**MISSISSIPPI DEPARTMENT OF TRANSPORTATION
TABLE OF CONTENTS**

**PROJECT: STBG-0020-01(283)/108902306 - Hinds
SP-0020-01(283)/108902306 - Hinds
SP-0020-01(283)/108902306 - Hinds
SP-0020-01(283)/108902306 - Rankin**

SECTION 904 - NOTICE TO BIDDERS NO. 6062

SECTION 904 - NOTICE TO BIDDERS NO. 6064

LIGHTING LAYOUT

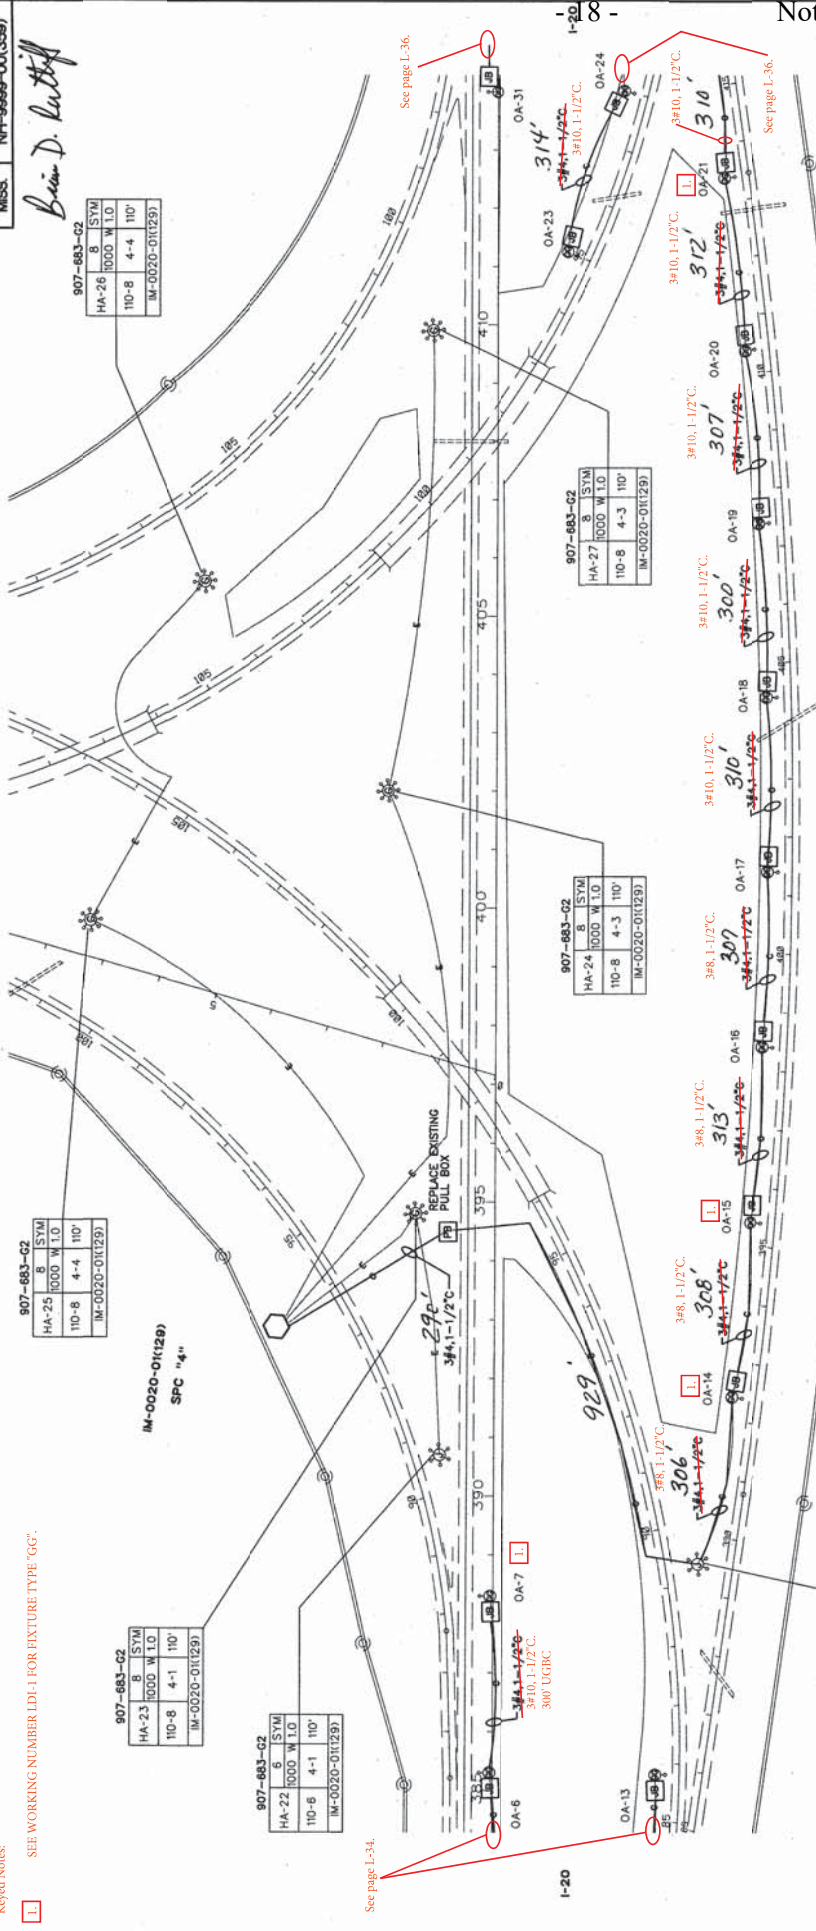
General Notes: (SPC-4)

A. As of May 2024 SPC-4 is damaged and shall be replaced. Contents and materials of the existing SPC-4 shall be salvaged and returned to MDOT.

B. Light fixtures fed from SPC-4 shall be upgraded to LED fixtures. This shall be a 1-1 replacement.

E. BC 2 low mast poles shall be repaired. Fixtures shall be upgraded to LED (1-1 replacement).

F. Cap existing conduit and abandon in place. New conductors and conduit shall be installed for low mast poles. Poles and foundations are existing to remain unless stated otherwise.

G. Replace damaged low mast poles (OA-14, OA-15, OA-21).

MISSISSIPPI DEPARTMENT OF TRANSPORTATION
 LIGHTING LAYOUT
 STA. 415+00 TO STA. 445+00

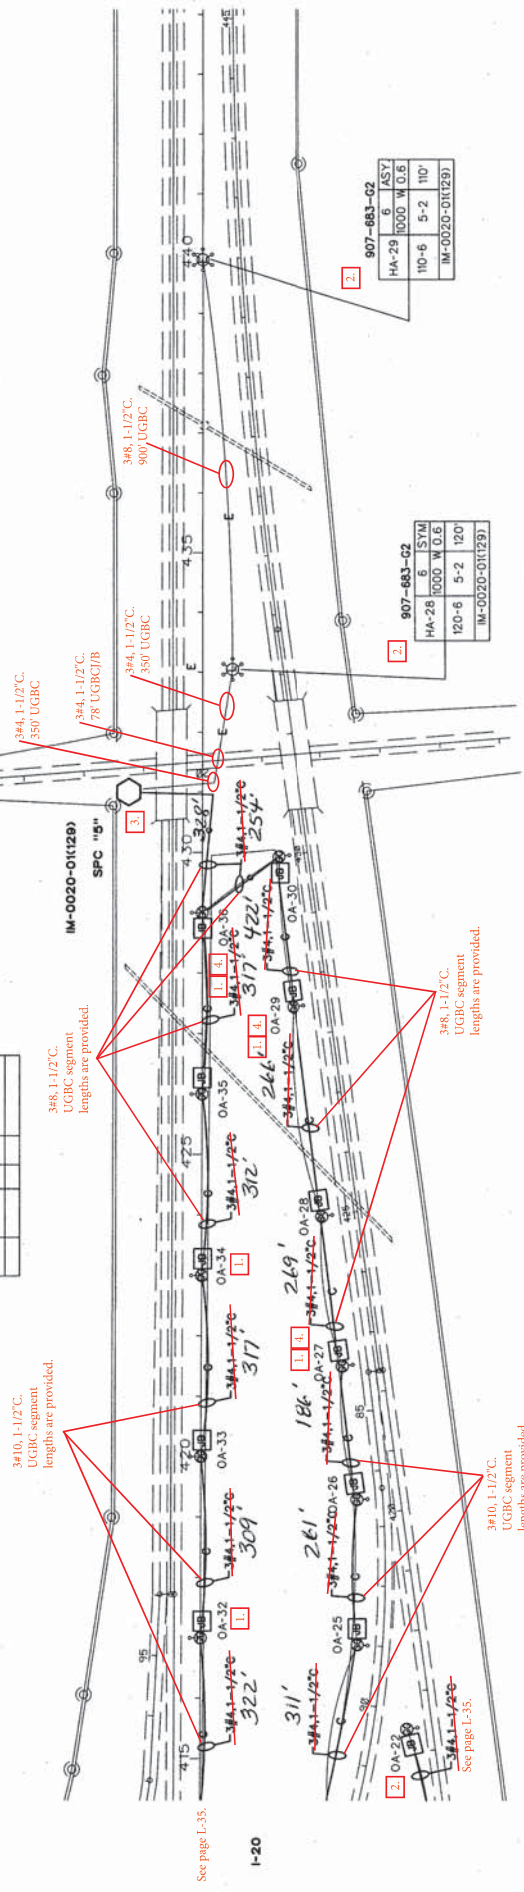
General Notes: (SPC-5)
 A. As of May 2024 SPC-5 is damaged and shall be replaced. Contents and materials of the existing SPC-5 shall be salvaged and returned to MDOT.
 B. Light fixtures fed from SPC-5 shall be upgraded to LED fixtures. This shall be a 1:1 replacement. Conduit and conductors shall be replaced. Poles and foundations are existing to remain unless stated otherwise.
 C. Replace damaged or fallen low mast poles.

- 1. CLEAN, RELEVEL AND RELAMP ALL HIGH MAST LOWERING DEVICES AND LUMINAIRES.
 SEE GG4 FOR ADDITIONAL INSTRUCTIONS.
- 2. INSPECT ALL POLES, REMOVE RUST AND CORROSION AND REPAINT THOSE AREAS WITH A ZINC RICH PAINT.
- 3. PROVIDE EROSION CONTROL MEASURES AROUND DISTURBED AREAS AS APPROVED BY THE ENGINEER.
- 4. INSTALL JUNCTION BOX AND CONCRETE PAD AT EACH GG LOW MAST ASSEMBLY.
- 5. INSTALL NEW SECONDARY POWER CONTROLLER.
- 6. REMOVE EXISTING SECONDARY POWER CONTROLLER.
- 7. REPAIR DAMAGED HANDHOLE COVERS. REPLACE MISSING HANDHOLE COVERS.
- 8. REPLACE ALL MISSING OR DAMAGED FUNCTION BOX AND PULL BOX COVERS.
- 9. REPLACE FALLEN POLES. (OA-27, OA-29, OA-33, OA-34, OA-36)
